**APPENDIX B**  
**EXPLANATION OF SIGNIFICANT DIFFERENCES**

**MassDEP COMMENTS ON  
EXPLANATION OF SIGNIFICANT DIFFERENCES  
SHEPLEY'S HILL LANDFILL  
FORMER FORT DEVENS ARMY INSTALLATION (RTN 2-0000662)  
JANUARY 7, 2013**

**EPA Comments on  
Draft Explanation of Significant Differences  
Land Use Controls to Restrict Use of Groundwater  
For Shepley's Hill Landfill Superfund Site  
Former Fort Devens, MA  
October 2012**

**FIGURE 2**  
**SHEPLEY'S HILL LANDFILL**  
**SITE LOCATION MAP**

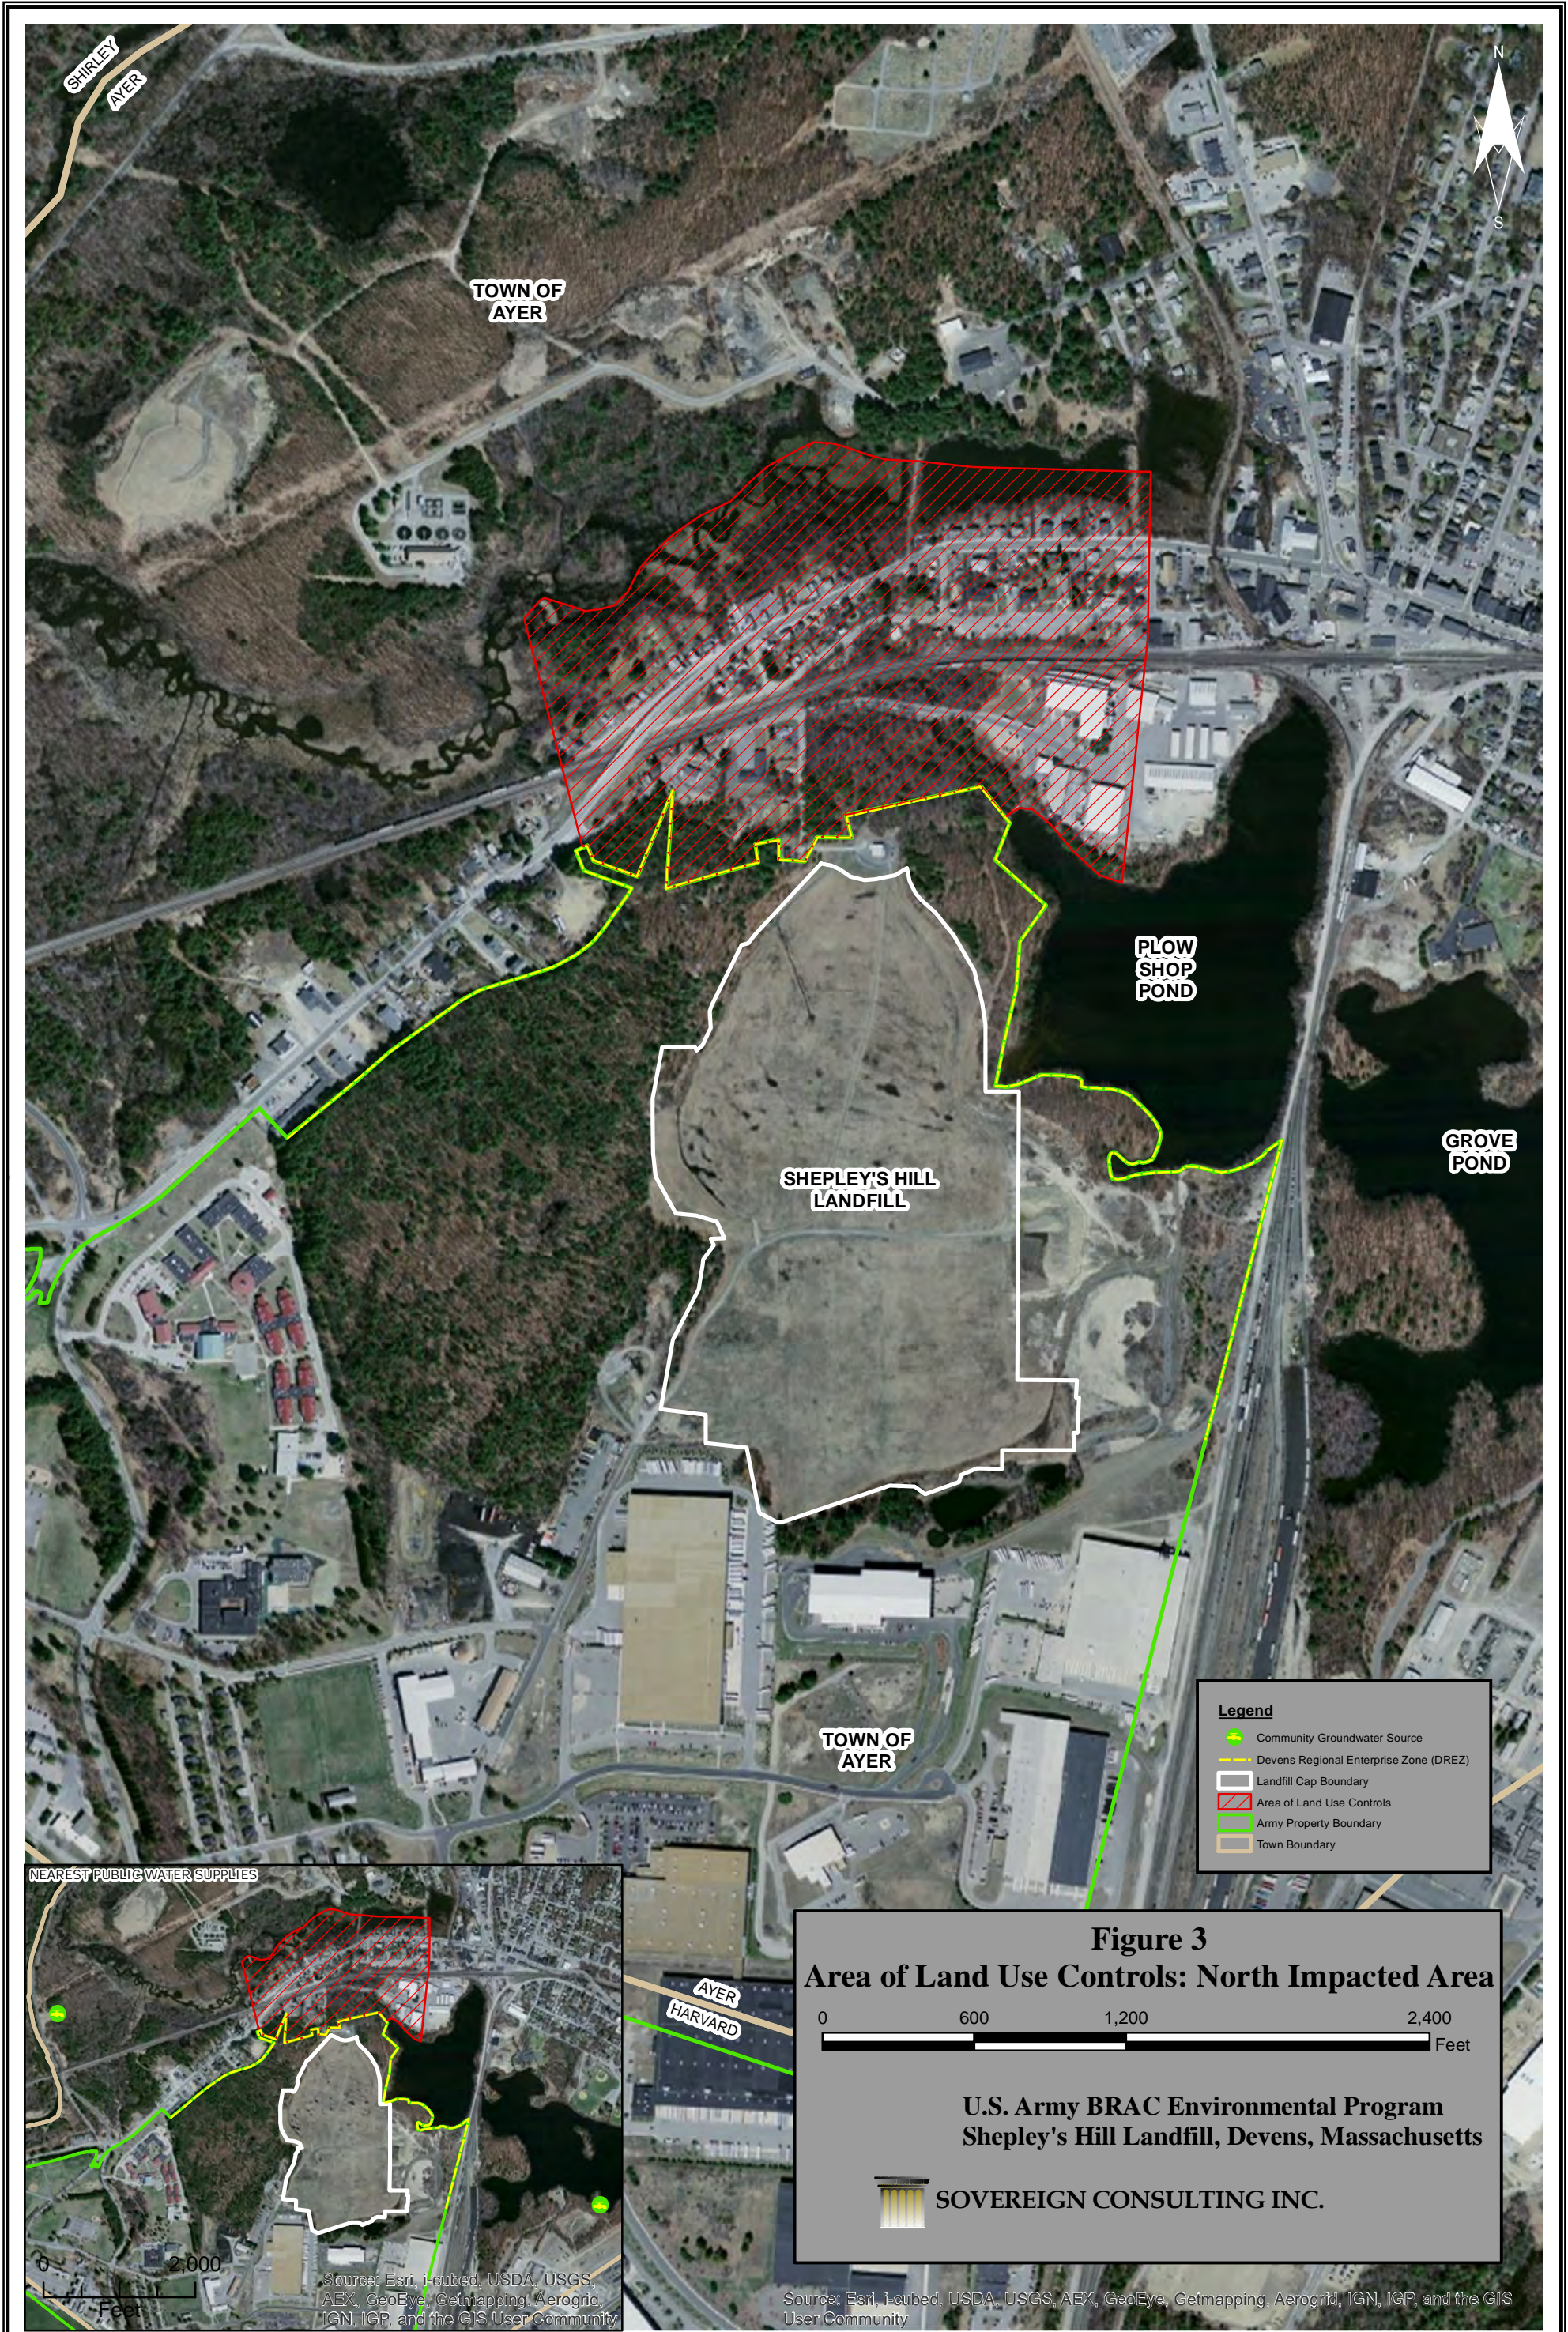
*The LUC boundary is approximately 400 feet from the edge of the northern impact area, not the Fort Devens’ property boundary. Any institutional controls will refer to the LUC boundary on a map (Figure 3) not distances from property boundaries. Therefore this extended boundary will create an additional buffer from the impacted groundwater. Figure 3 of the ESD depicts the area to be restricted under the LUCs and will be included in the moratorium developed with the Town of Ayer.*
